Lake City Community Center

Design Commission #2 February 19, 2026

Responses to Design Commission Meeting #1 Recommendations

RESPONSE TO RECOMMENDATION #1, 2 & 8 - EXPAND ENTRY AREA ON 28TH AVENUE NE

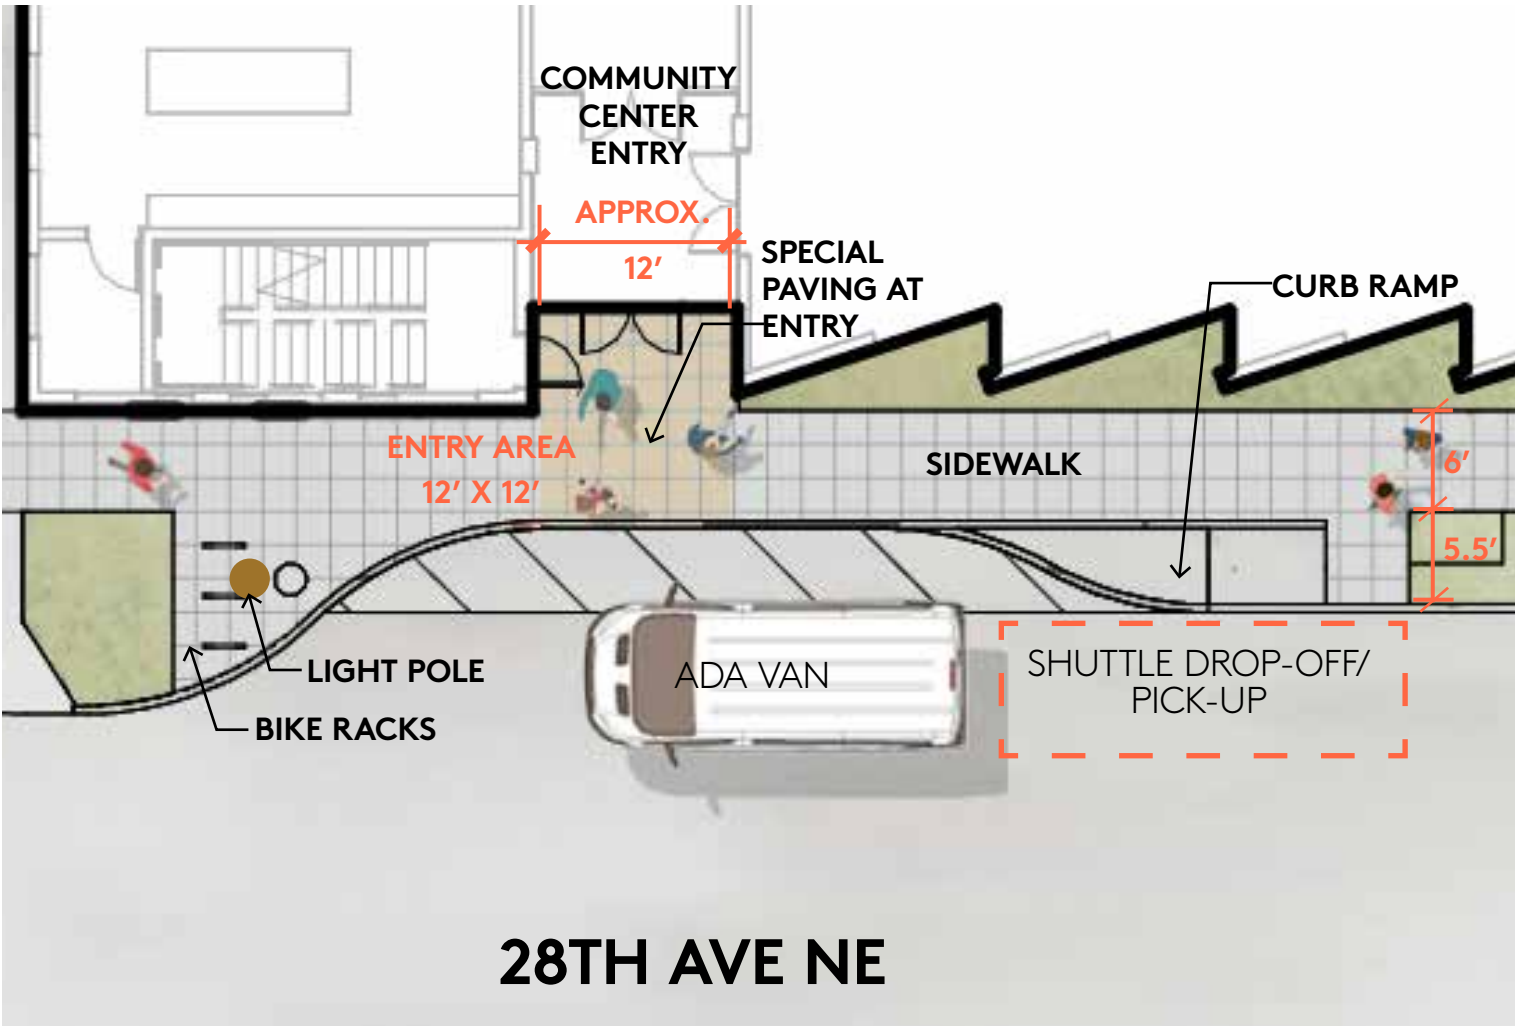
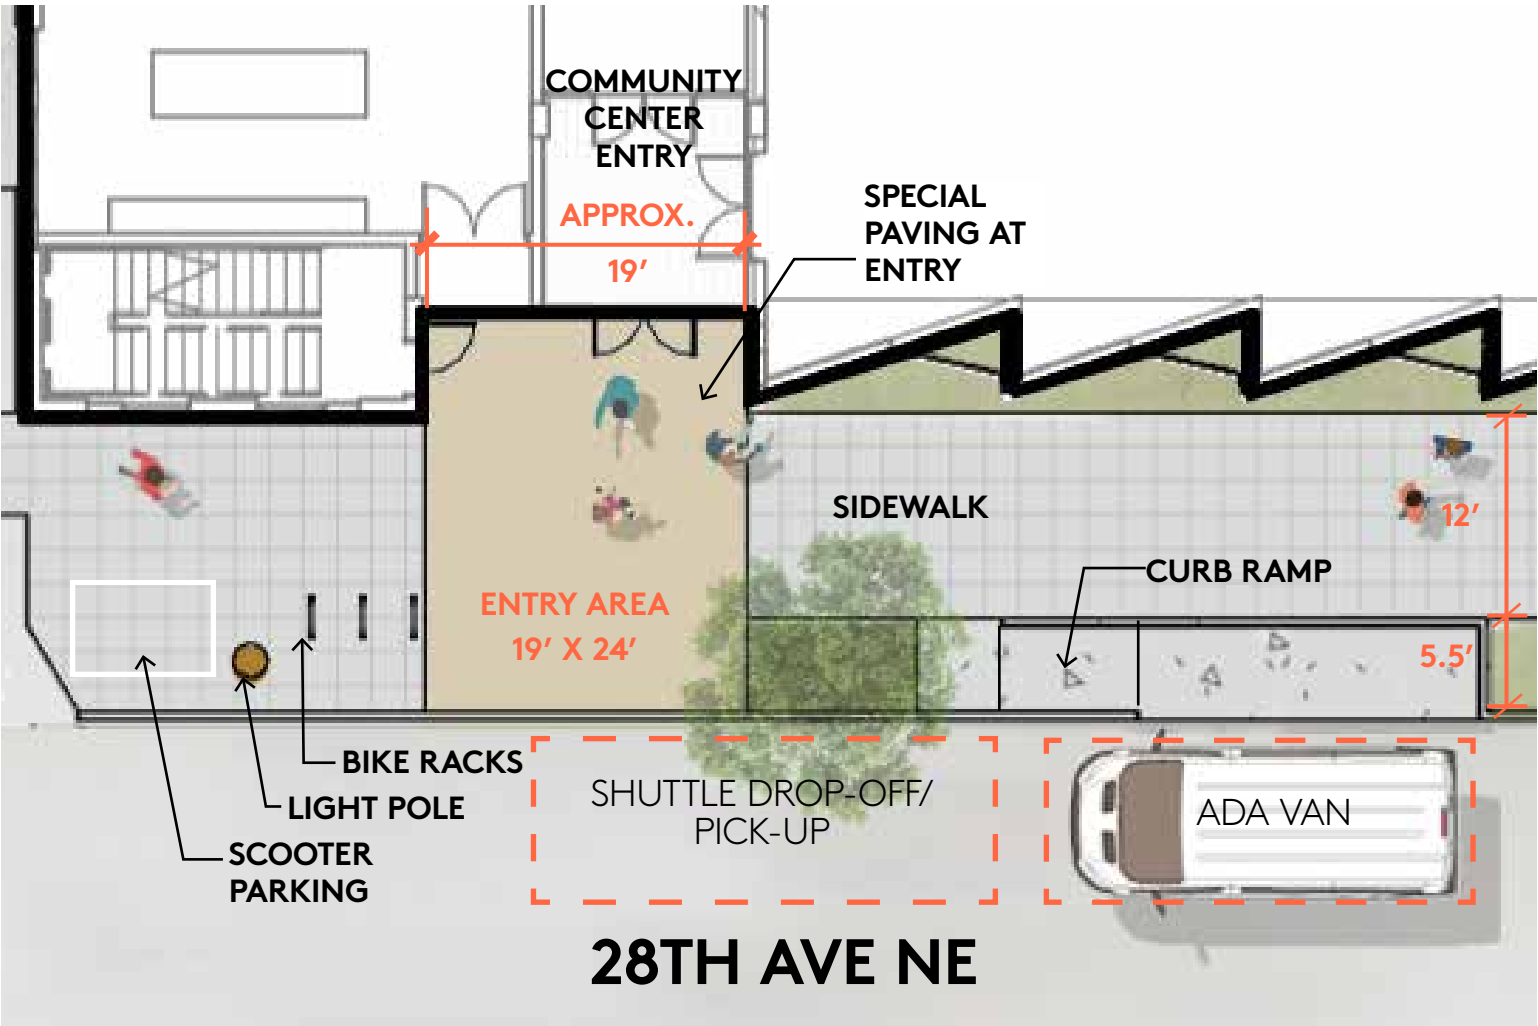
#1 Expand entry area on 28th Avenue NE

Explore building setbacks, street modifications, or relocated loading for more generous public space at and near the community center entrance

#2 Enhance entry prominence

Develop architectural features (canopy, materiality, massing) for better identification of entry to community center

#8 Coordinate with SDOT

Explore curb line modifications for additional entry space at 28th Ave NE and crosswalk mural opportunities

PREVIOUS DESIGN

REVISED DESIGN

RESPONSES TO RECOMMENDATIONS #3 & 4 - COMMUNITY CENTER TERRACE & PARK INTEGRATION

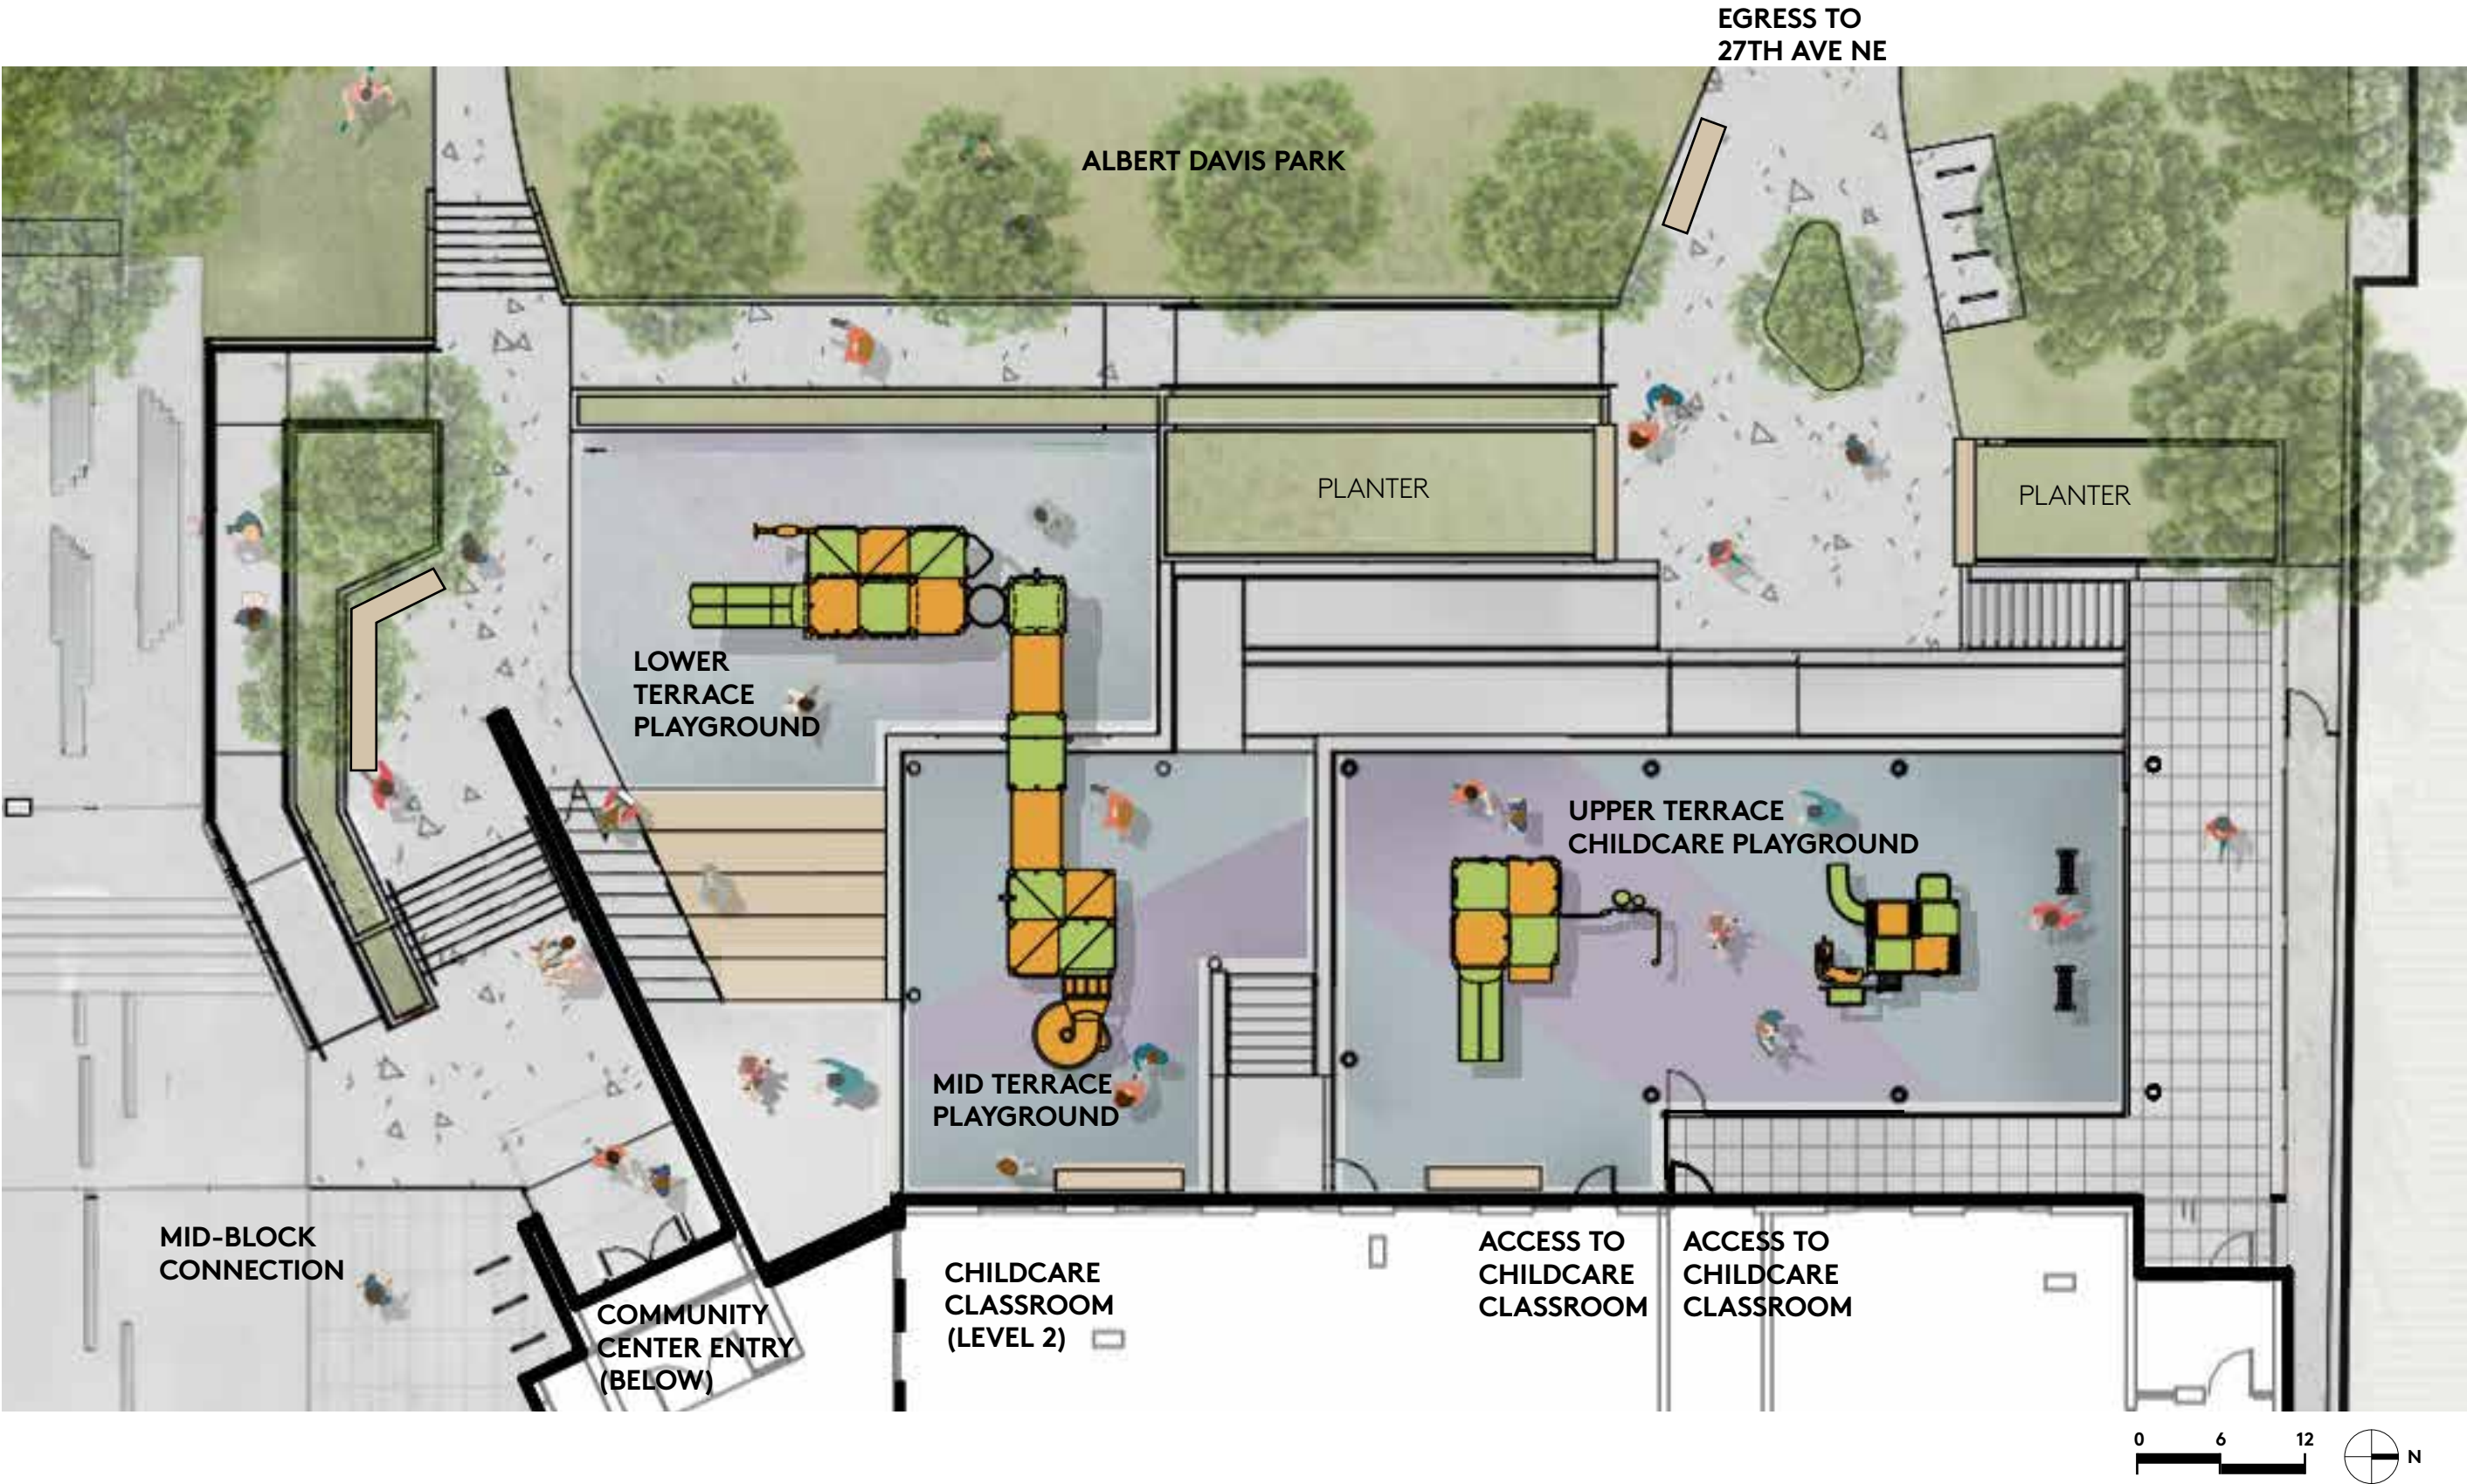
#3 Simplify circulation

Reduce ramp complexity on side of building that connects community center to Albert Davis Park;
improve wayfinding

#4 Improve integration with park

Study relocating the community center playground area to a location closer to Albert Davis Park

RESPONSES TO RECOMMENDATIONS #12 - SITE PLAN

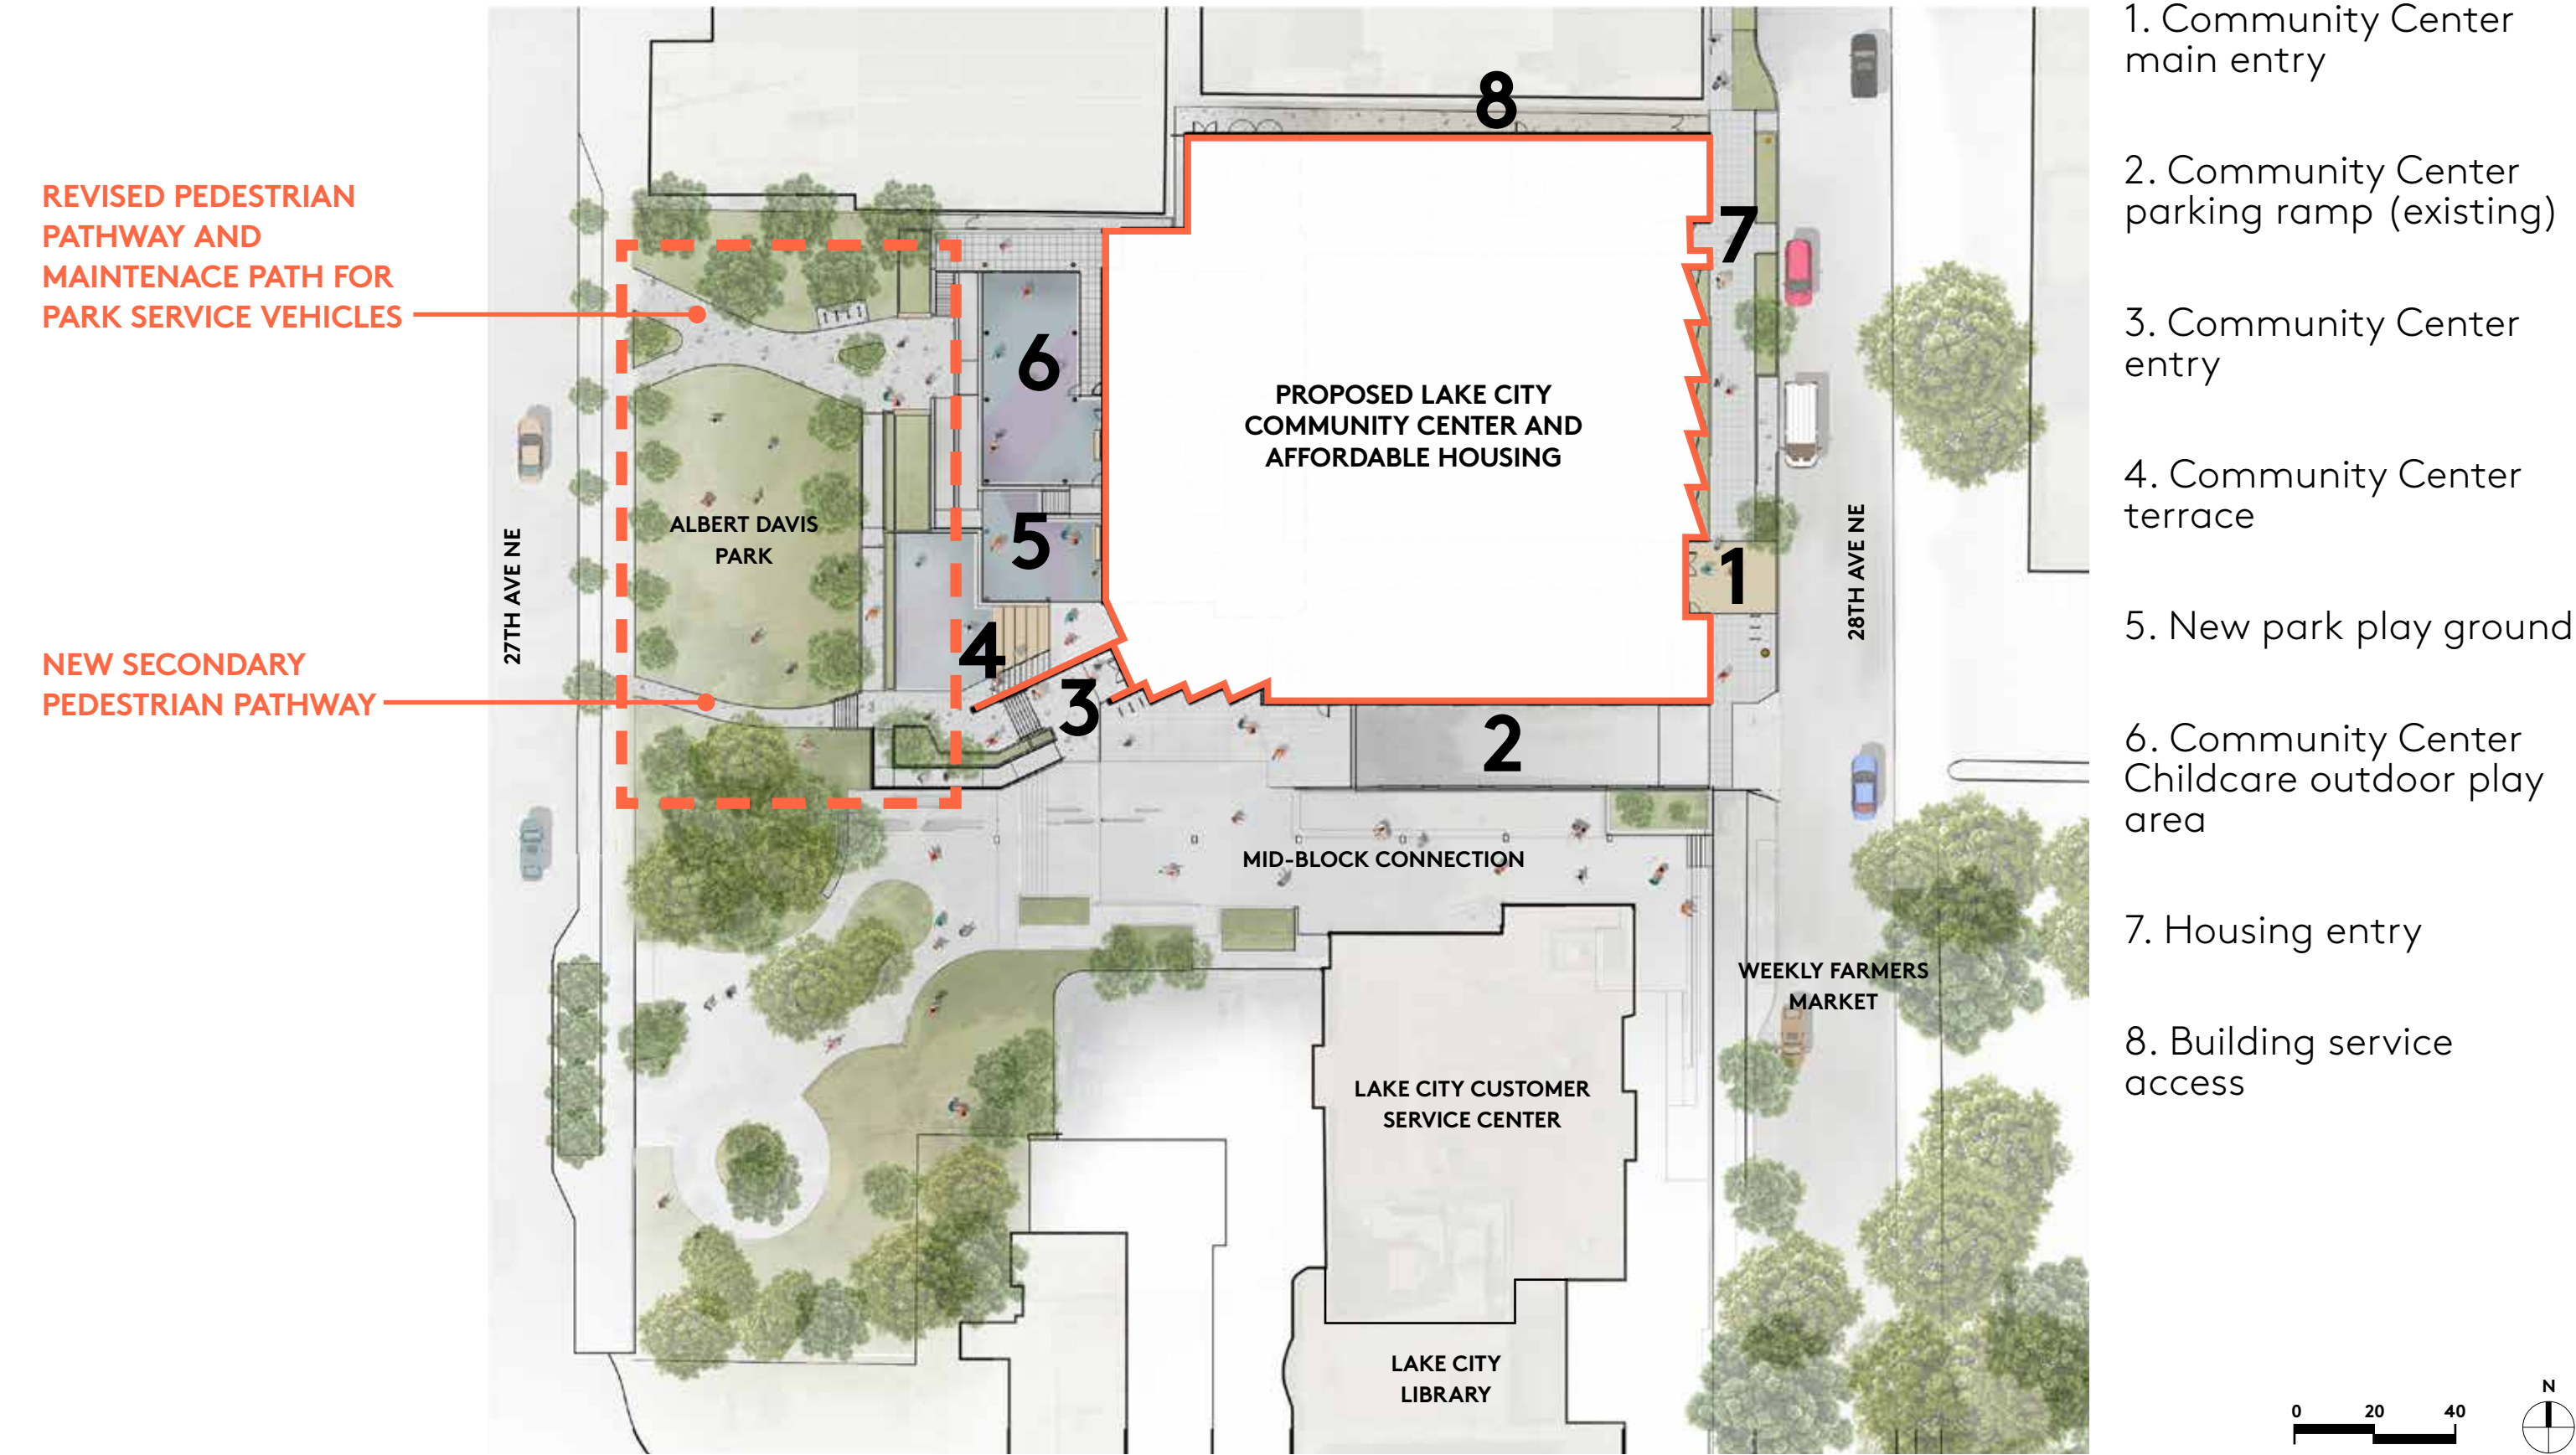
Address circulation and potential street improvements on 27th Ave NE as well as 28th Ave NE

Additional study is needed to provide clear connections from 27th Ave NE to the community center and its entrance oriented to Albert Davis Park. Better visibility from 27th Ave NE could relieve some of the pressure that the building needs to perform along 28th Ave NE.
